802.3cu D1.1 PMD Spec Proposed Changes

P802.3cu 100 Gb/s and 400 Gb/s over SMF at
100 Gb/s per Wavelength Task Force

20 January 2020

TDECQ - $10\log_{10}(C_{EQ})$ Explanation Confirmation

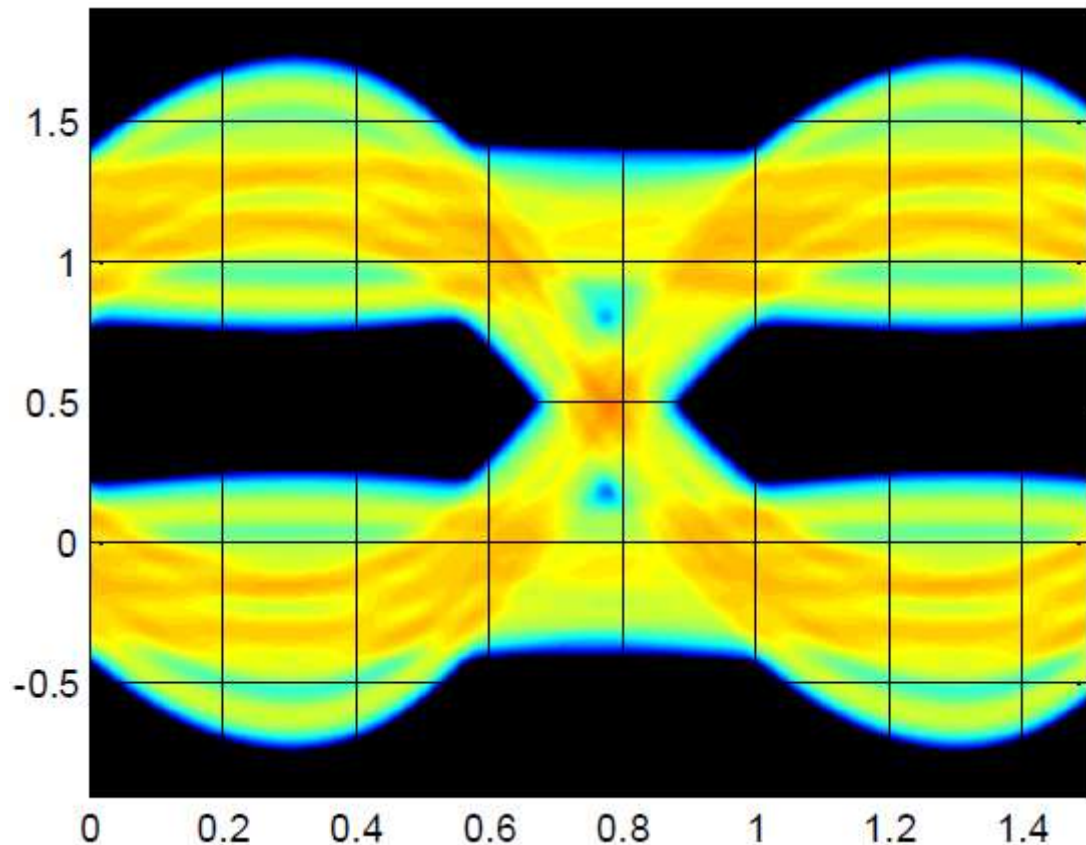
- “TDECQ - $10\log_{10}(C_{EQ})$ is not a good indicator of how hard the EQ has to work, nor of it’s likely resilience to receiver impairments.”
- “The transmitter most likely to be affected by receiver non-linearity, quantization, or other sampling errors, is the TX with the most severe effective eye-closure out of the O/E”
- “There is no value in adding a TDECQ - $10\log_{10}(C_{EQ})$ limit. Adding one unnecessarily **limits** the use of a tool (**transmitter pre-emphasis**) which can improve transmitter yield and cost, and link margins.”
- Jonathan correctly points out that TDECQ - $10\log_{10}(C_{EQ})$ limit can exclude good TX, i.e. it’s a lousy spec

TDECQ - $10\log_{10}(C_{EQ})$ Explanation Confirmation

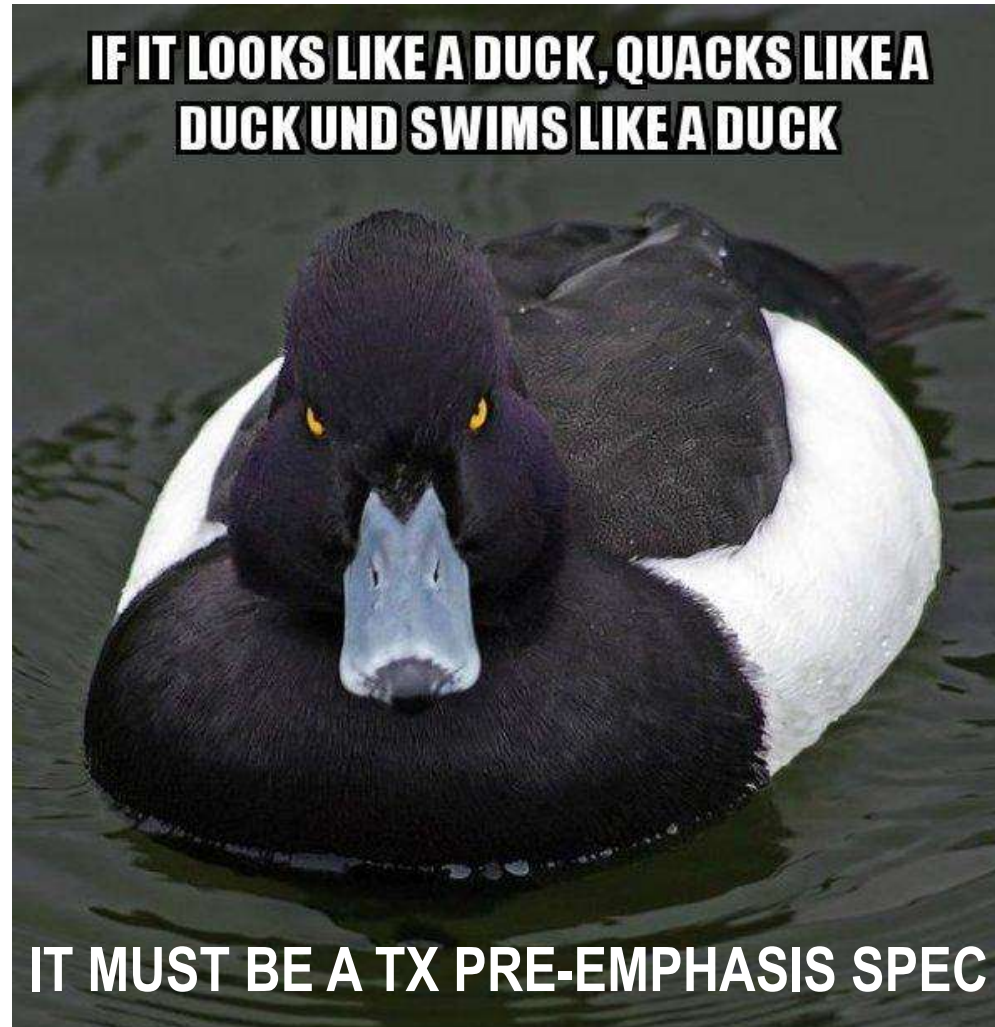
- Piers Dawe and Mellanox team analysis
- TDECQ - $10\log_{10}(C_{EQ})$ stops use of “... excessive emphasis to make a bad (noisy and/or distorted and/or inappropriate chirp) transmitter pass when it should have failed”

26.6 GBaud PAM4 1305nm λ 13.3GHz RX BW

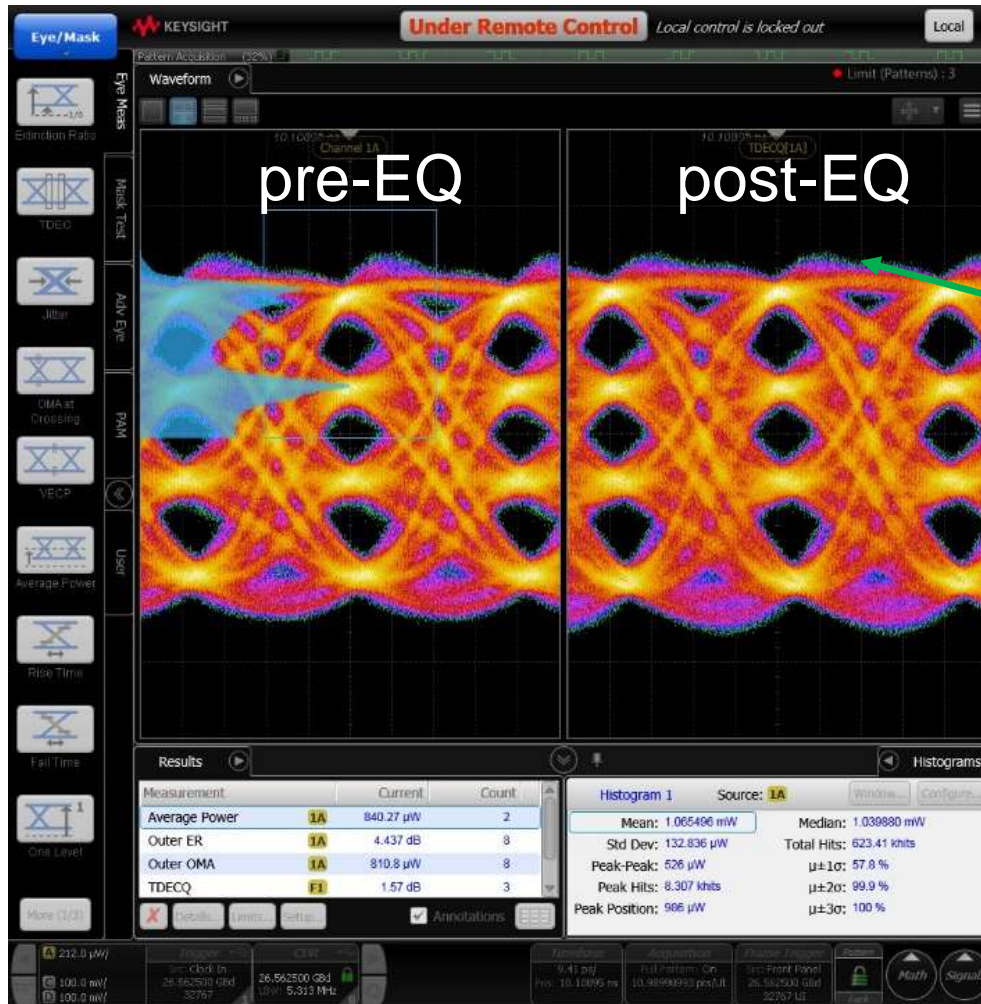
$H_{EQ}(f)$ is mild Low Pass

$C_{EQ} = 0.96$

TDECQ - $10\log_{10}(C_{EQ})$
= 1.4 dB

This spec would not limit
TX pre-emphasis

26.6 GBaud PAM4 1305nm λ 13.3GHz RX BW

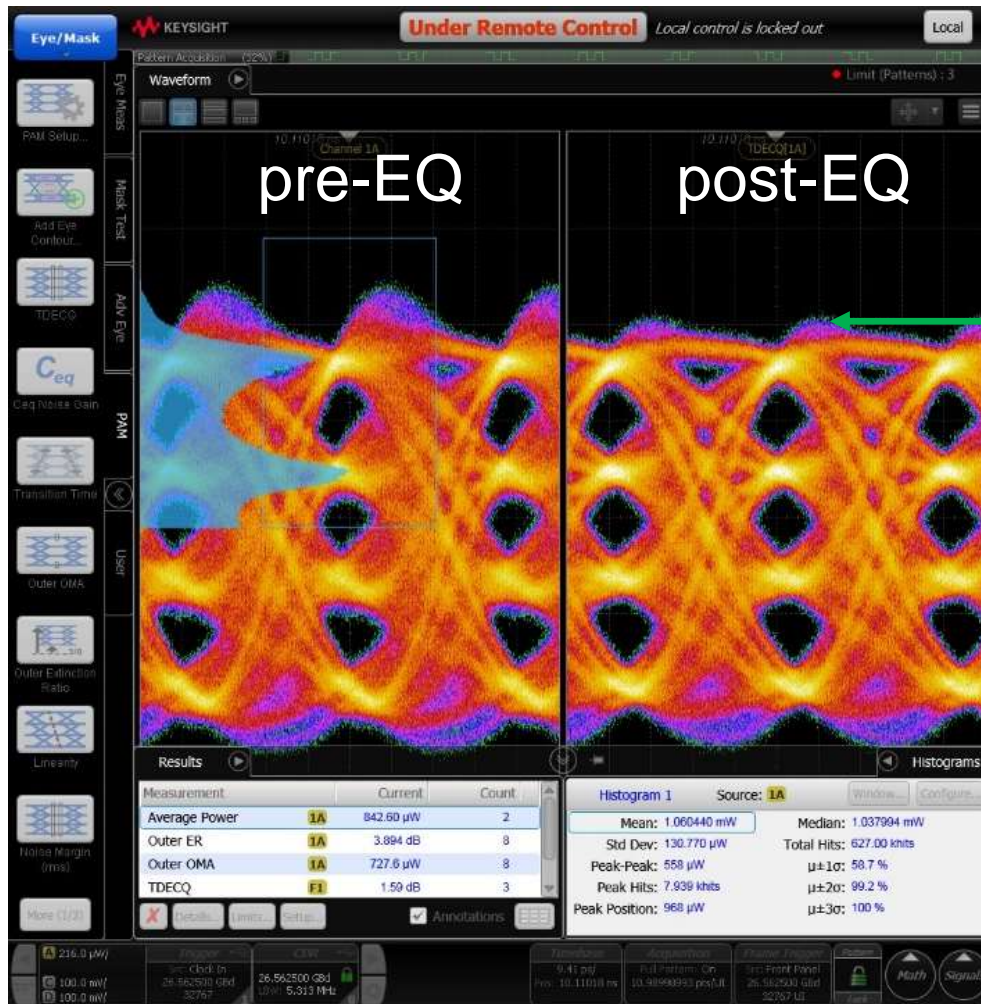
$H_{EQ}(f)$ is Low Pass

$C_{EQ} = 0.87$

TDECQ - $10\log_{10}(C_{EQ})$
= 2.1 dB

This spec would not limit
TX pre-emphasis

26.6 GBaud PAM4 1305nm λ 13.3GHz RX BW

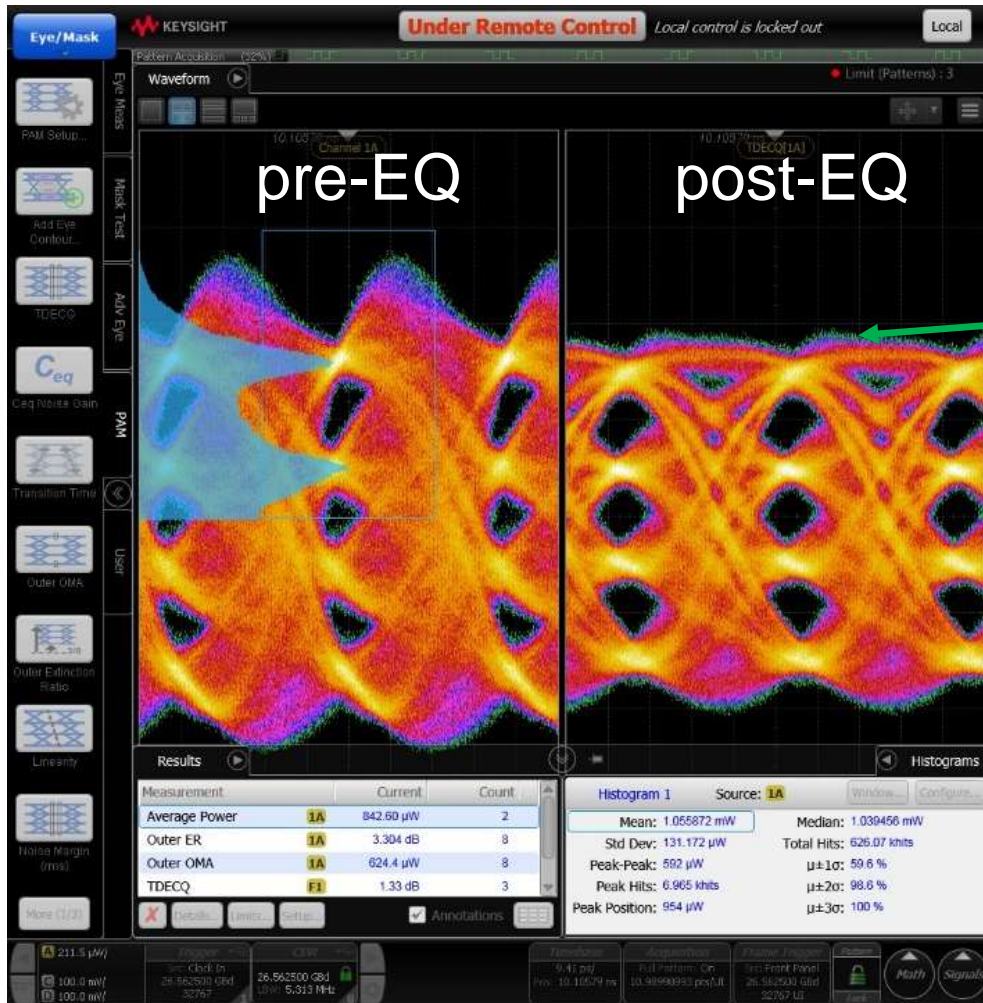
$H_{EQ}(f)$ is hard Low Pass

$C_{EQ} = 0.79$

TDECQ - $10\log_{10}(C_{EQ})$
= 3.2 dB

This spec would not limit
TX pre-emphasis

26.6 GBaud PAM4 LR8 λ s 5 Corner Data

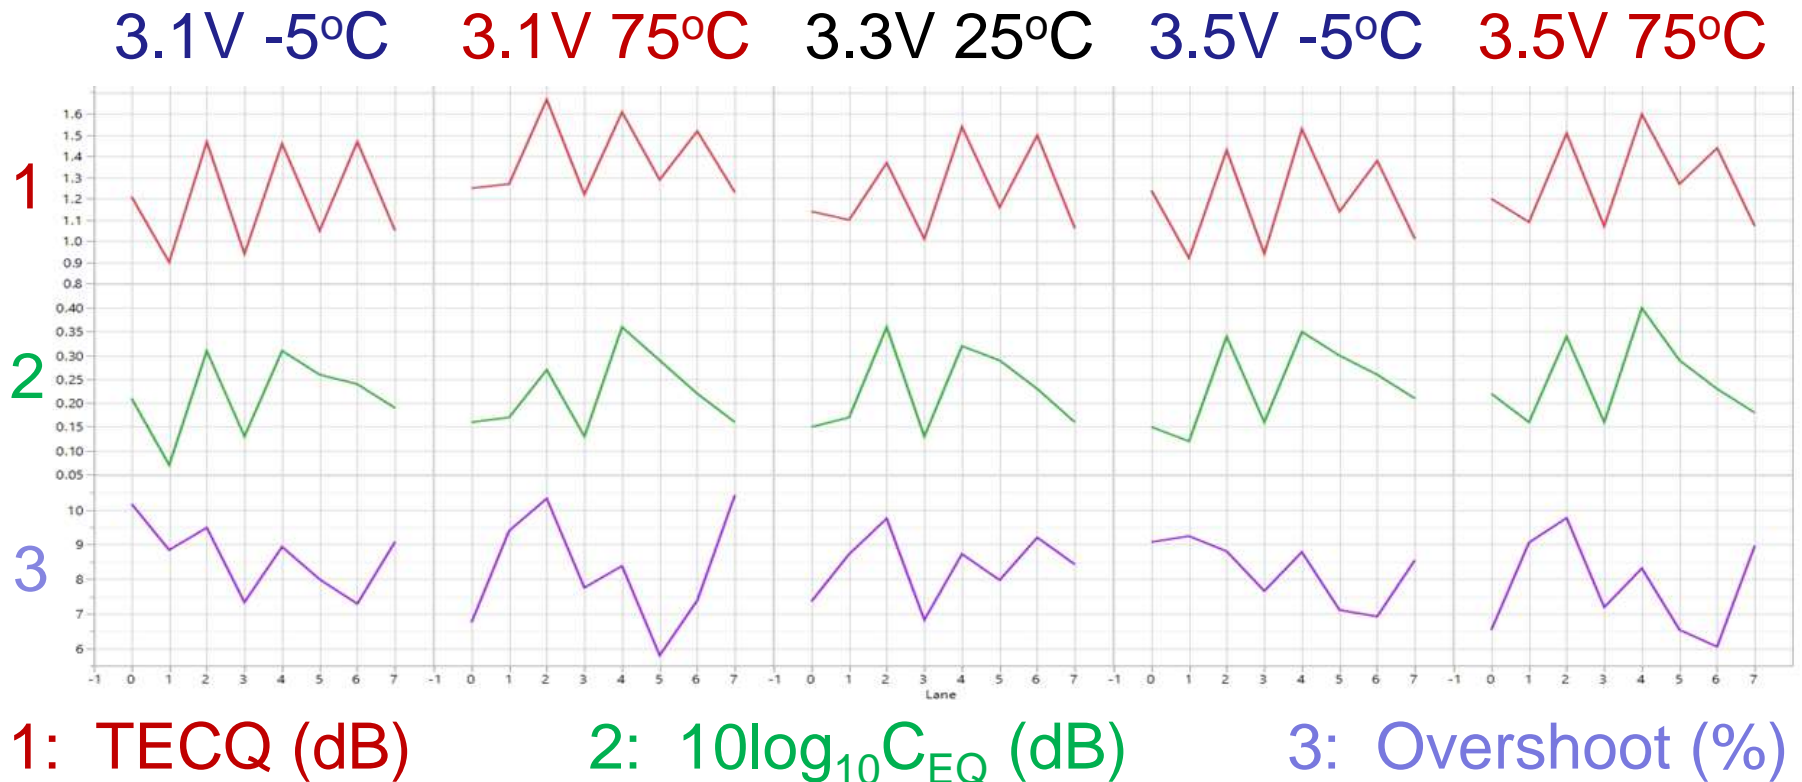
- Only qualitative correlation between C_{EQ} and Overshoot; $TDECQ - 10\log_{10}(C_{EQ})$ is a lousy spec

TX Signal Historical Time Domain Spec Limits

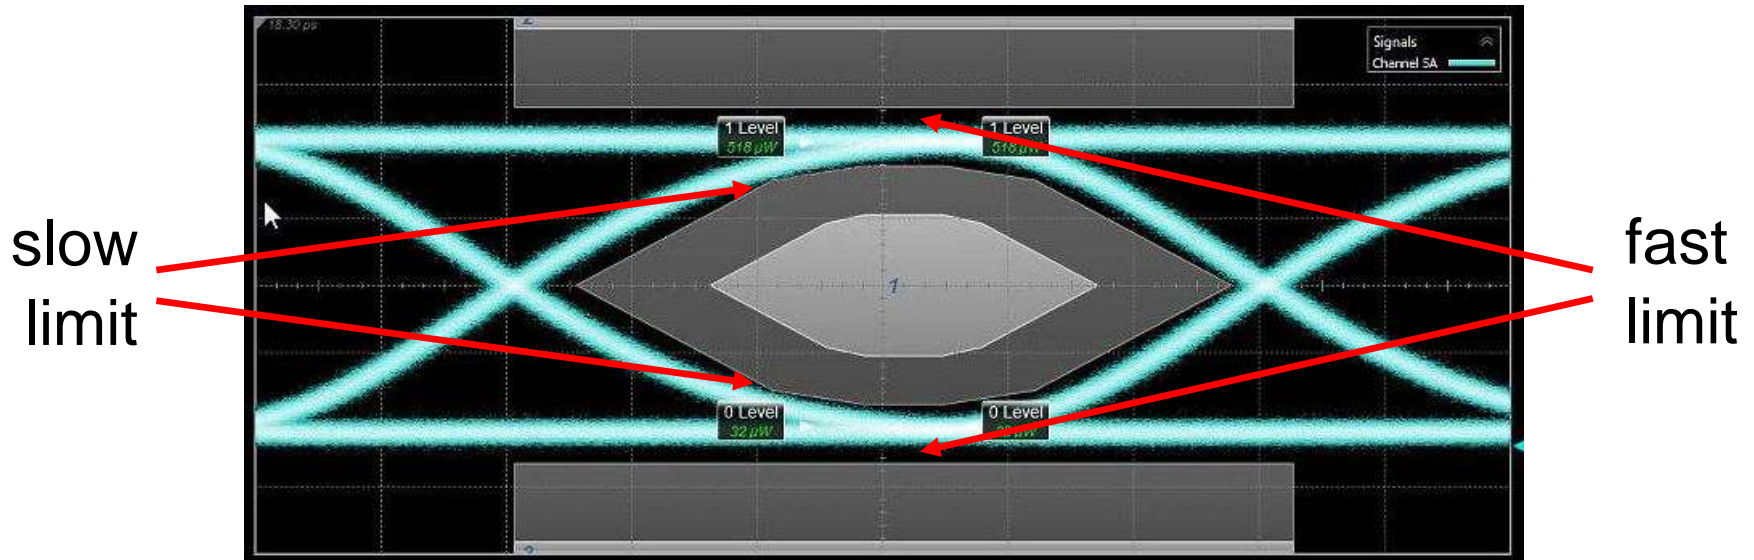
- Successfully used with BER spec limits for decades
- Requires open TX eye, which NRZ signals have
- Dropped as spec for PAM4 signals because the TX eye can be closed, yet still recoverable by adaptive equalizer $H_{eq}(f)$
- Simple solution: use NRZ signal for TX time domain tests
